# PCN - 26 066

<b>Product Name:</b>	HPL-503 PWR CABLES	
	HVDC 125A	
<b>Product Manager:</b>	Grace Zuo / Vera Liao	
<b>Subject:</b>	Notification of Change with Immediate Effectivity	
<b>Distribution:</b>	Affected customers	
<b>Type of Change:</b>	Design Change	
<b>Change Description:</b>	Changes Implemented to improve mechanical integrity of the contact: 1. Reduced the inner hole profile depth and modified the profile geometry. 2. Changed through hole to stepped blind hole. 3. Rounded off the sharp corners.	
<b>Reason for Change:</b>	For strengthening the mechanical compatibility.	
<b>Affected Parts:</b>	10183597-X-005BXLFF;10199058-0X-0XXLF See Affected Parts.xls file for details	
<b>Effective Date of Change:</b>	June,30 2026	
<b>Last Time Buy Date:</b>	NA	
<b>Earliest Disty Return Date:</b>	NA	
<b>Last Time Shipment Date</b>	NA	
<b>Datasheet Attached?</b>	Yes	
<b>Qual/Test Data Attached?</b>	Yes	
<b>Samples Availability Date:</b>	June,30 2026

# Change in contact drill profile for the 125A DC Whip & Phonograph

HVDC 125A

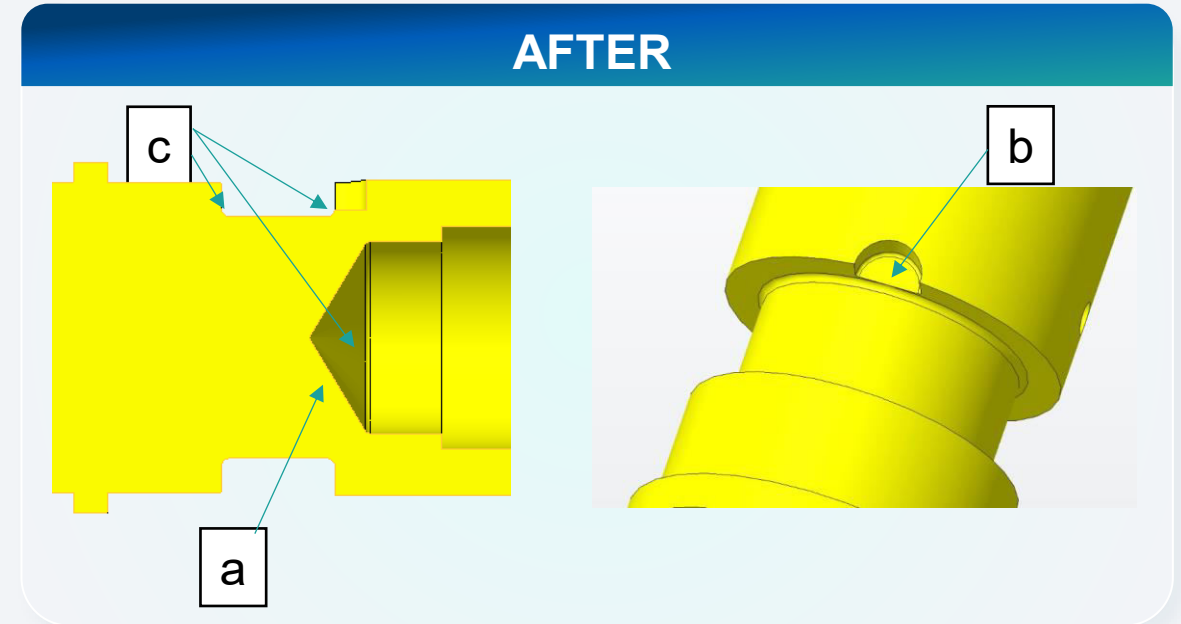
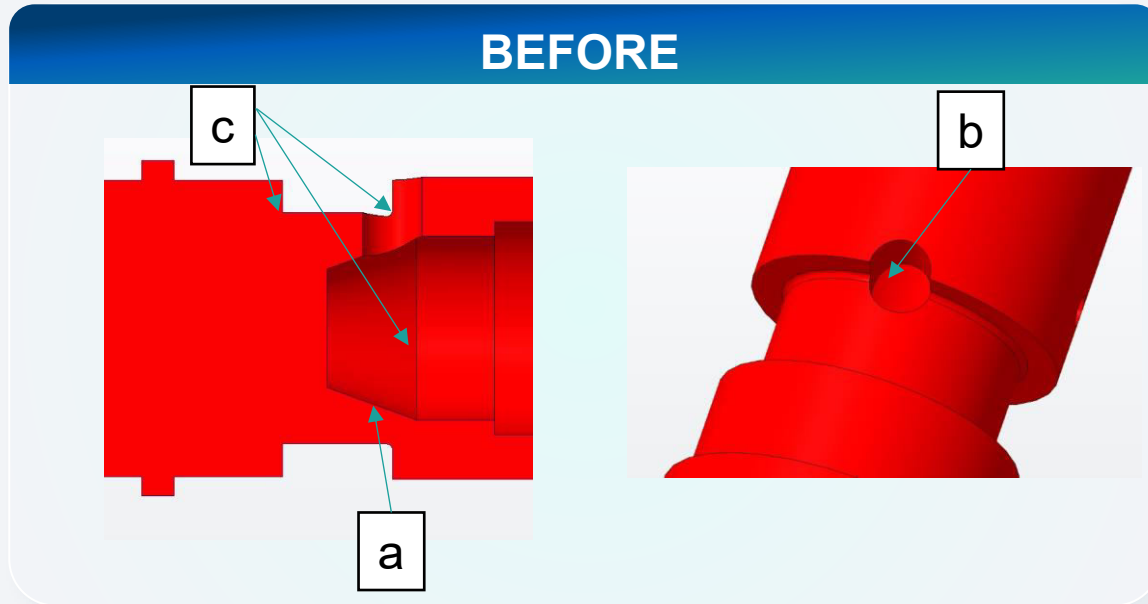
Changes Implemented to improve mechanical integrity of the contact:

- a) Reduced the inner hole profile depth and modified the profile geometry.
- b) Changed through hole to stepped blind hole.
- c) Rounded off the sharp corners.
